Mini Holland Cycle Scheme

Stage 1 Road Safety Audit

Ref: 2524/032/A105/BOR/2016

London Borough of Enfield

FILE: PROPOSED A105 ROUTE SHEET 6	
SCALE: NTS	DRAWING NO: B240G001-SK-A105-001-06
REV: E

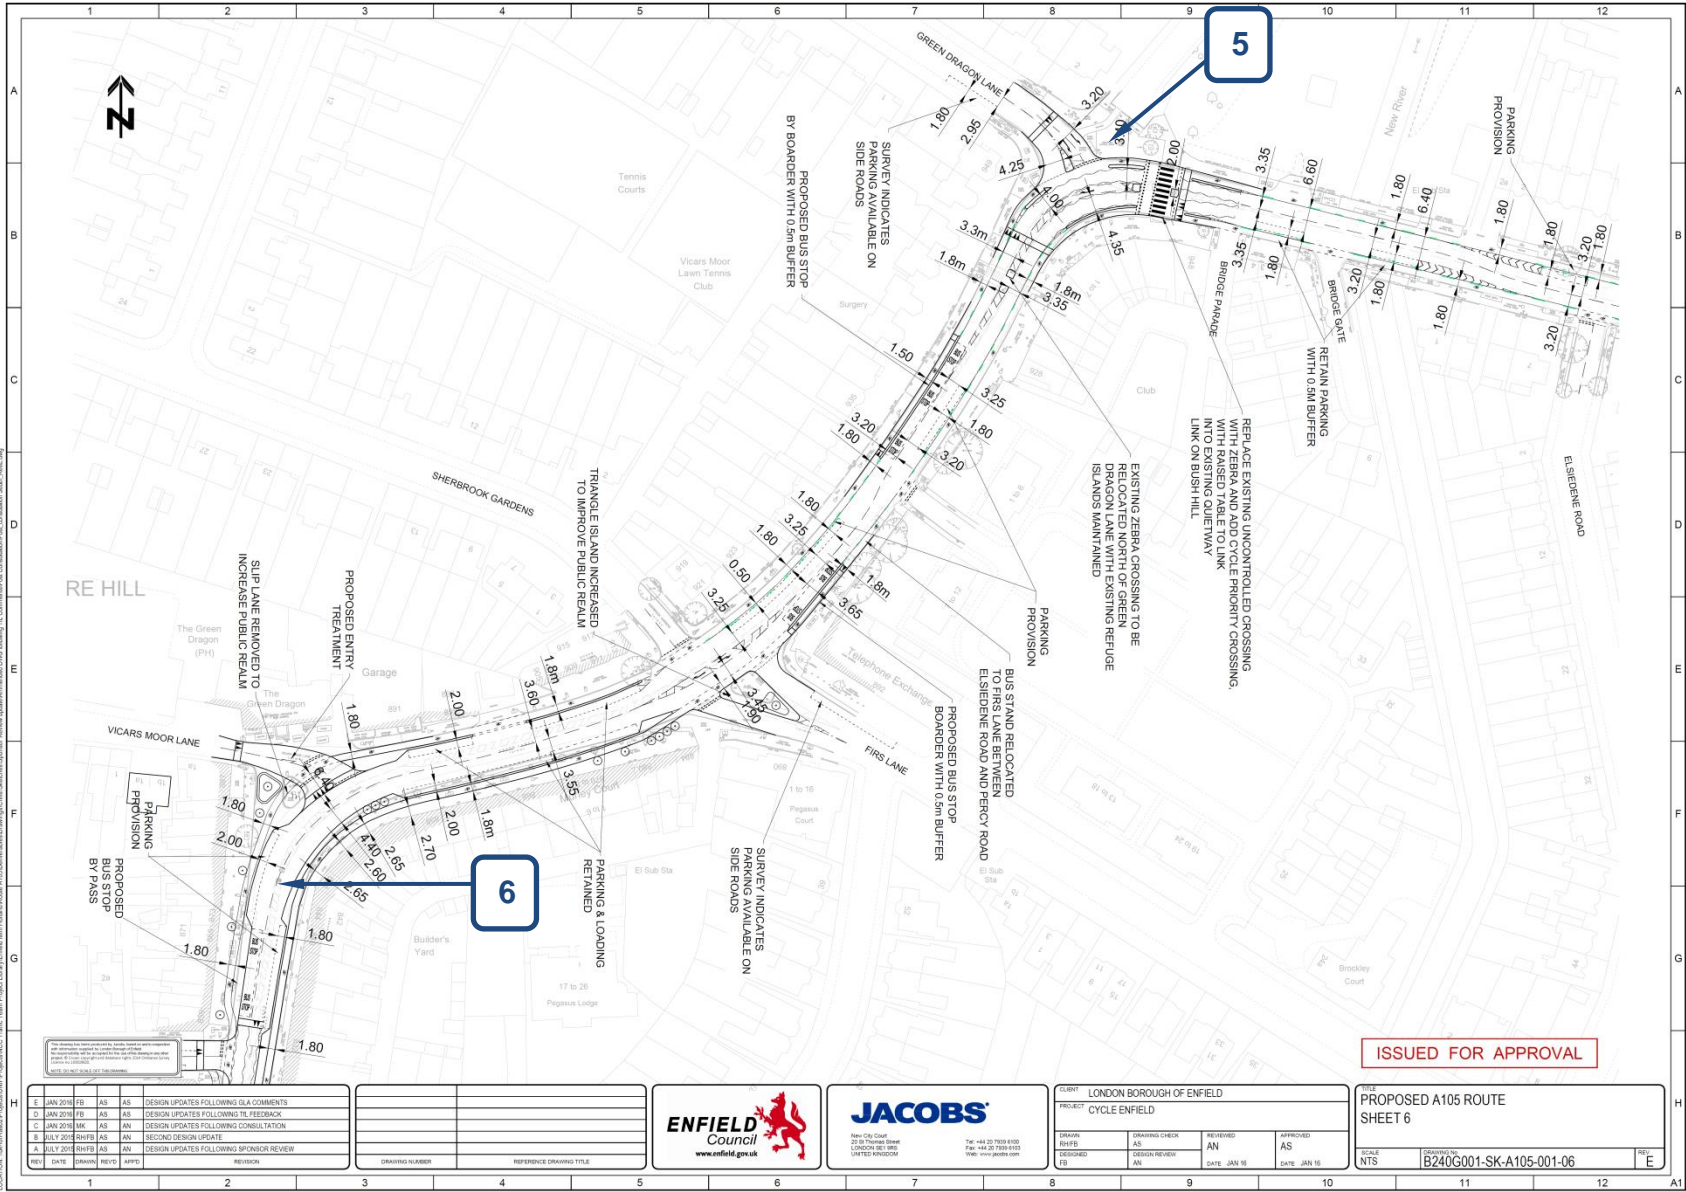
Location: 5 - Drawing 001-06 - At the junction with Green Dragon Lane

Location: 6 - Drawing 001-06 – Winchmore Hill – existing pedestrian refuge location

Design Organisation Response	Accepted
<p>This is an accepted design change which will be looked at the detailed design stage. However, at this stage, the preliminary design drawing has been amended to provide a connection between the Bush Hill cycle route and the A105 via the parallel cycle/pedestrian crossing. The existing cycle track connecting Bush Hill and Green Dragon Lane would be retained to continue to provide a connection between Bush Hill and Green Dragon Lane.</p>	
Client Organisation Comments	
<p>Designer's response accepted.</p>

Design Organisation Response	Partially Accepted
------------------------------	--------------------

The existing refuge island south of Vicars Moor Lane cannot be retained as the carriageway has been narrowed in order to provide the cycle tracks, parking bays and acceptable traffic lane widths. While we accept the comment that the removal of the refuge will affect the desire lines, the following mitigation is in place:

FILE	PROPOSED A105 ROUTE SHEET 7
SCALE	NTS
DRAWING NO.	B240G001-SK-A105-001-07
REV.	E

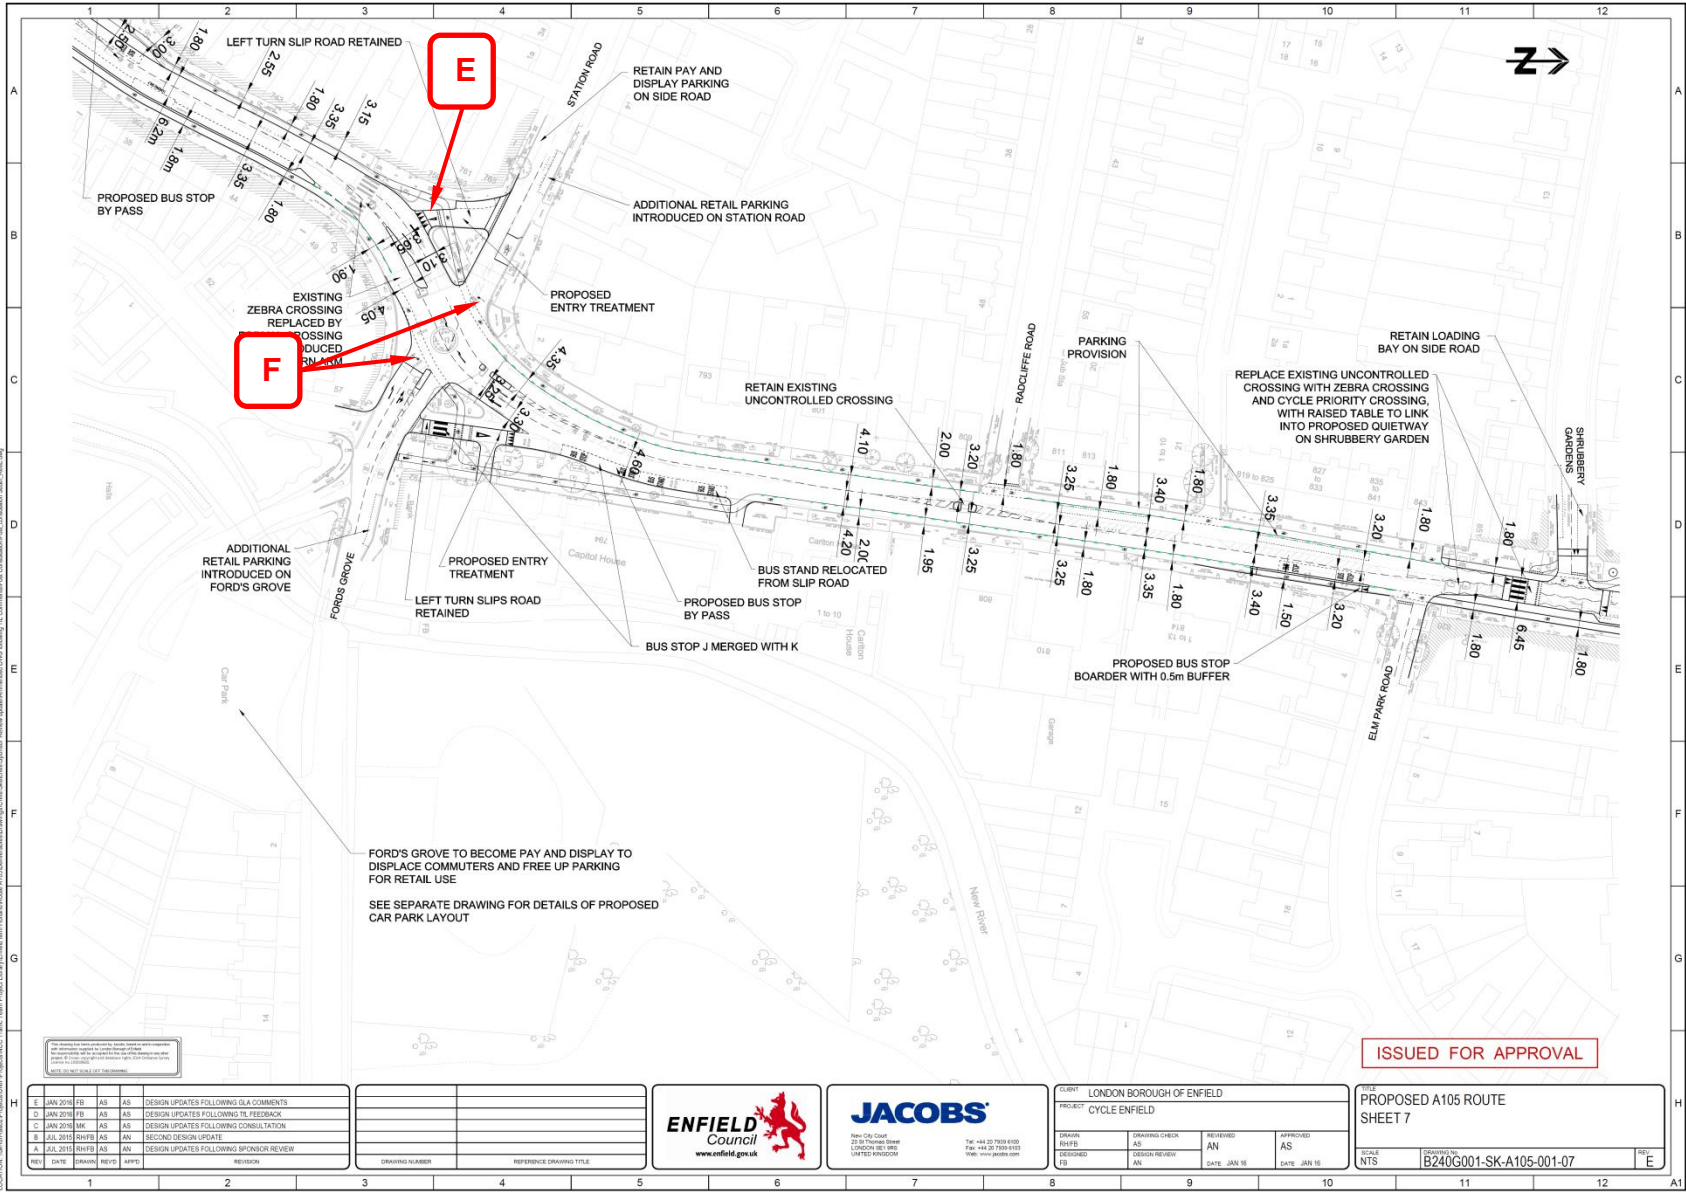
3.5 DRAWING 001-07

Design Organisation Response	Accepted

Design Organisation Response	Rejected
<p>A cycle early release cannot be incorporated into the design due to its implications on the junction's capacity. Transport for London is currently implementing 2-Stage right turns, without early release. The Traffic Infrastructure team within TfL have confirmed that 2 Stage right turns without early release can be implemented at these locations. The volume of right turn cycles is anticipated to be low as Station Road and Ford's Grove do not form part of the cycle network.</p> <p>Signage will be located on the approach to junctions so cyclists are informed of the facility.</p>	
Client Organisation Comments	
Designer's response accepted

FILE: PROPOSED A105 ROUTE SHEET 8	
SCALE: NTS	DRAWING NO: B240G001-SK-A105-001-08
REV: E

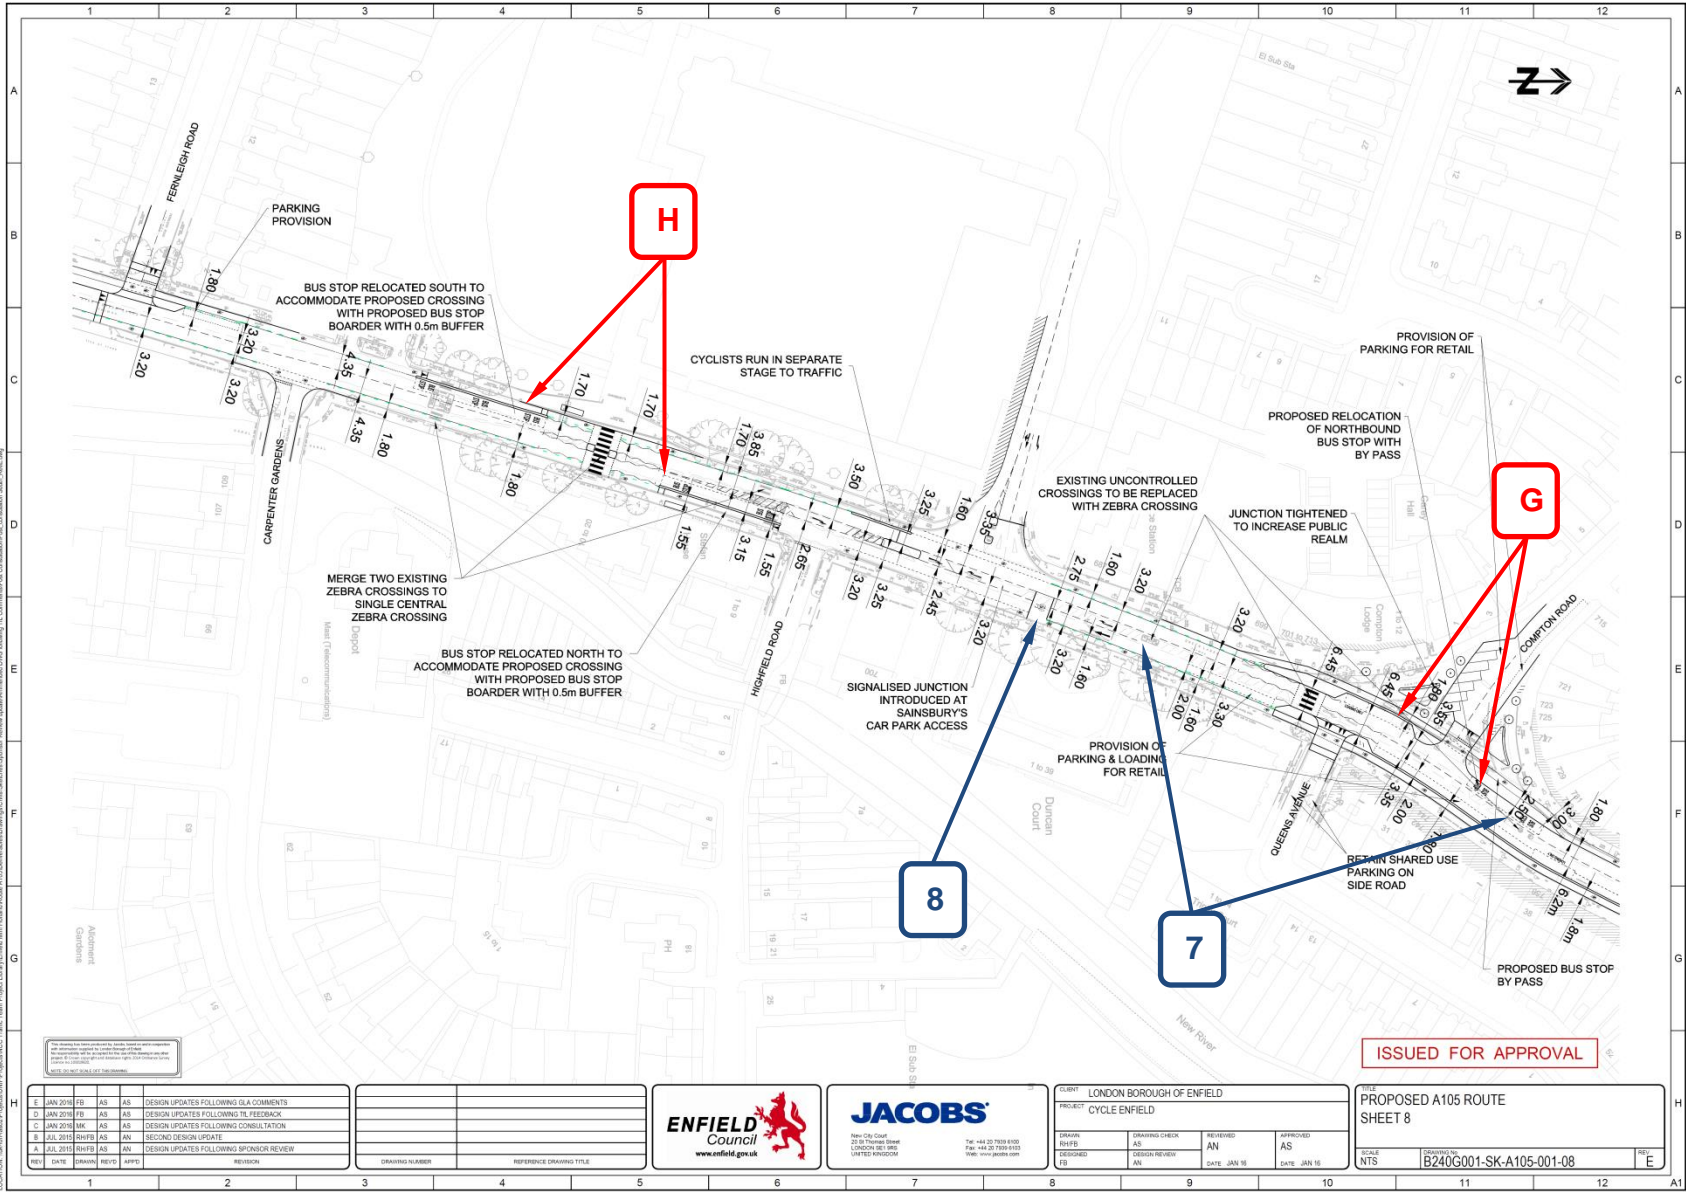
3.6 DRAWING 001-08

Adequate side road visibility should be provided and maintained free from obstruction. The bus stop and loading bays could be relocated to provide appropriate side road visibility. Additional speed reducing features could be introduced to minimise the relocation distance.

Location: 7 - Drawing 001-08 – Winchmore Hill – existing pedestrian refuge locations

Location: 8 - Drawing 001-08 – At Duncan Court

Design Organisation Response	Rejected
<p>The bus stop is served by the 329 and 629, as well as the N29. The 629 is a school bus so the only regular bus is the 329, which has a frequency of 8 PCUs per hour. So the amount of time when the bus stop is in use over the hour will be low. Also the bus cage is 22m long so a bus would be located in the front portion of the bus cage and not block back to the rear of the cage.</p> <p>It is not considered possible to relocate the bus stop further north, as this will reduce the footway.</p> <p>The loading bay is located 20m from the side road and is 6m in length, so will not be used by MGVs/HGVs or other high sided vehicles.</p> <p>It is accepted that the visibility splays are below recommend length. However, although reduced, the visibility splays are comparable with existing. The proposed design is considered better in terms of visibility as Compton Road is at right angles to the A105, whereas previously it was at an acute angle, even though both the right and the left turns were permitted.</p> <p>Furthermore, the scheme reduces the carriageway width, which is anticipated to reduce traffic speeds on the A105.</p>

Design Organisation Response	Rejected
<p>The suggested 'tail to tail' layout was considered either side of the crossing. However, the concern was that this would result in traffic regularly blocking back over the zebra crossings. A review of the bus stops has shown that the vast majority of passengers boarding and alighting at the two existing bus stops are travelling to/from the Sainsbury's store and therefore relocating the bus stops away from the supermarket was not considered satisfactory and tail to tail bus stops would result in the crossing being away from pedestrian desire lines, increasing the potential for informal crossing. Therefore it is felt that the proposed design represents the optimum layout for the location. The potential number of vehicles overtaking buses at speed is considered to be low.</p>	
Client Organisation Comments	
<p>Designer's response accepted but post implementation monitoring will be carried out.</p>

Design Organisation Response	Rejected
------------------------------	----------

TITLE	PROPOSED A105 ROUTE SHEET 9
SCALE	NTS
DRAWING NO.	B240G001-SK-A105-001-09
SHEET	9 OF 9

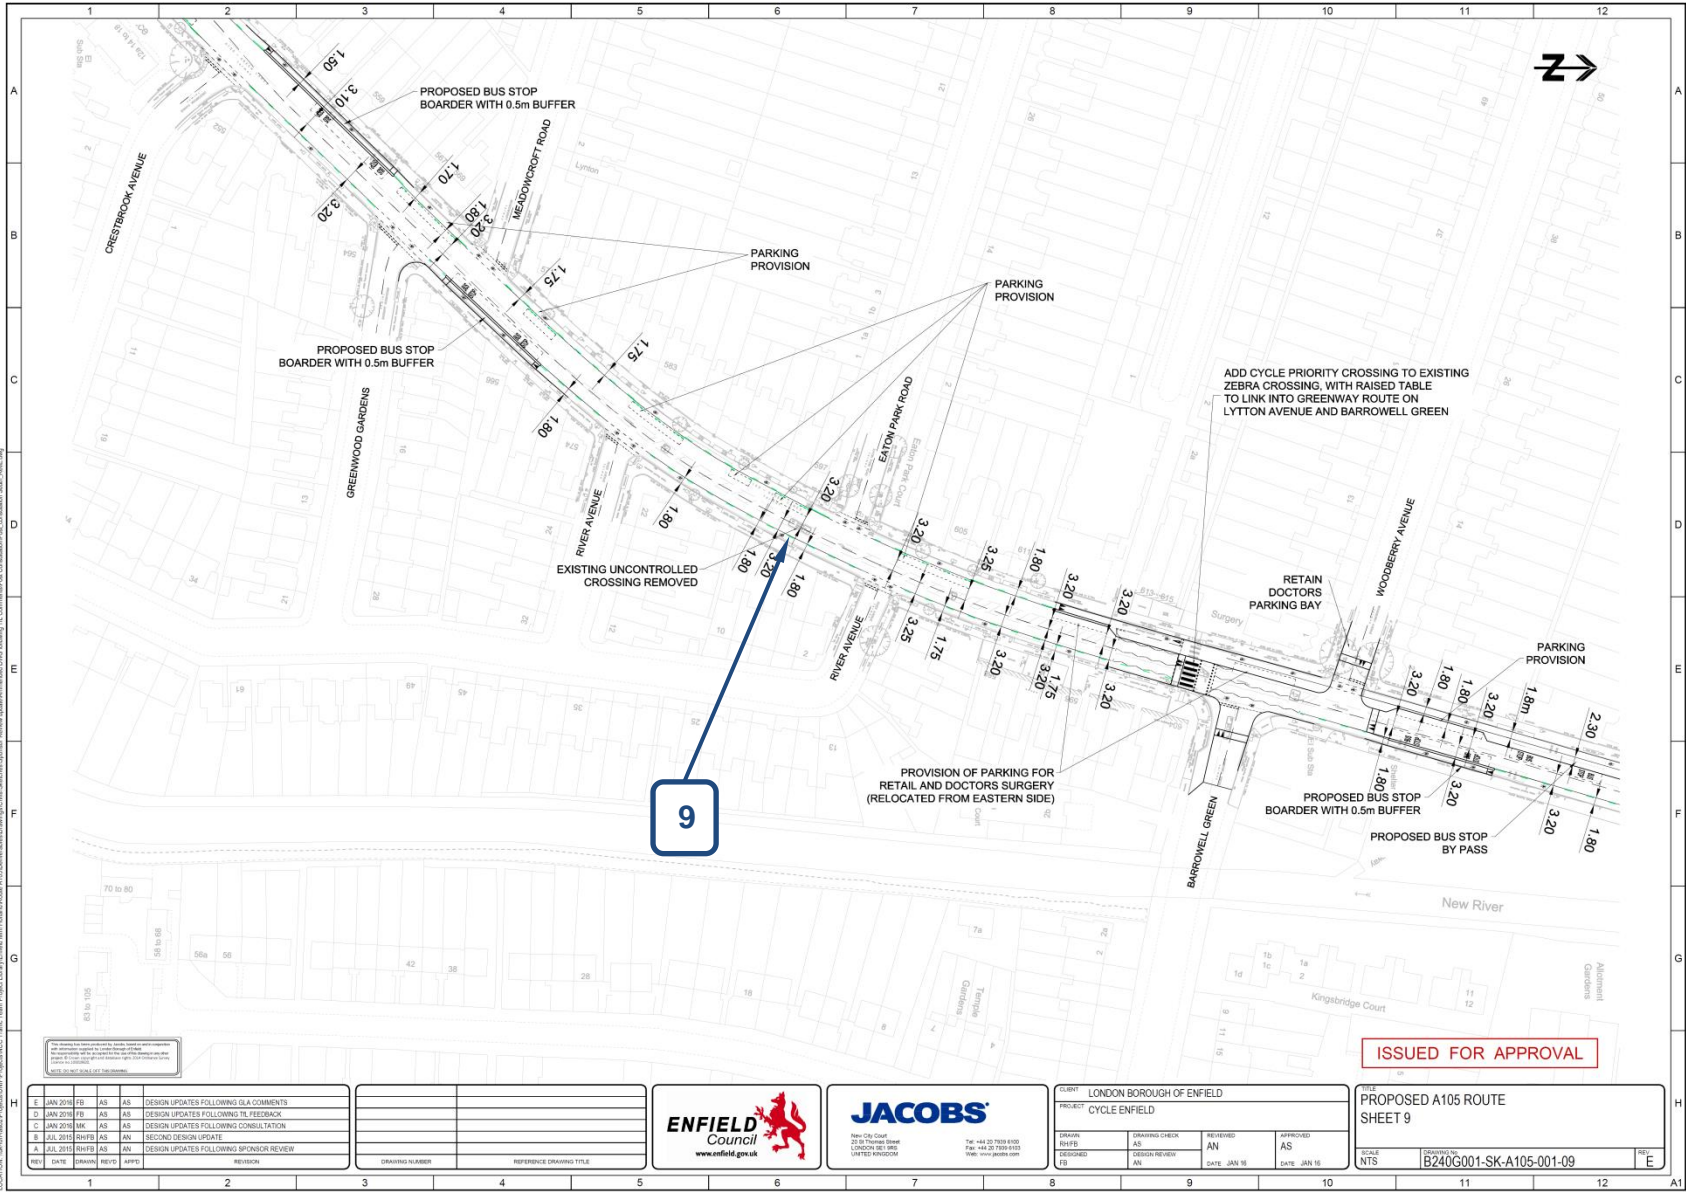
Location: 9 - Drawing 001-09 – South of Eaton Park Road

Design Organisation Response
